COA 18-59

500 S 10th Street

Consideration of an approval for replacement of the existing asphalt shingle roof with 5V Crimp metal roof.

HISTORIC PRESERVATION BOARD : PUBLIC HEARING

Water Damage
Chimney leak

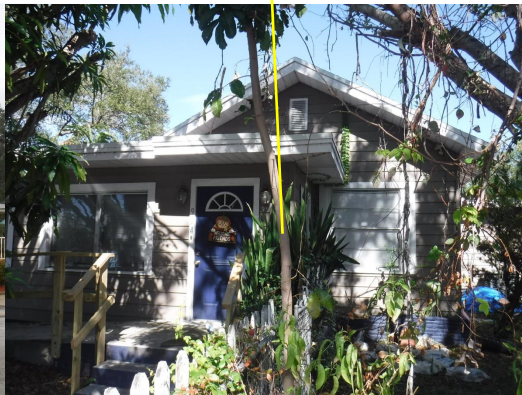
Pictures provided by the applicant showing the outside and inside damage caused by the roof leaks.
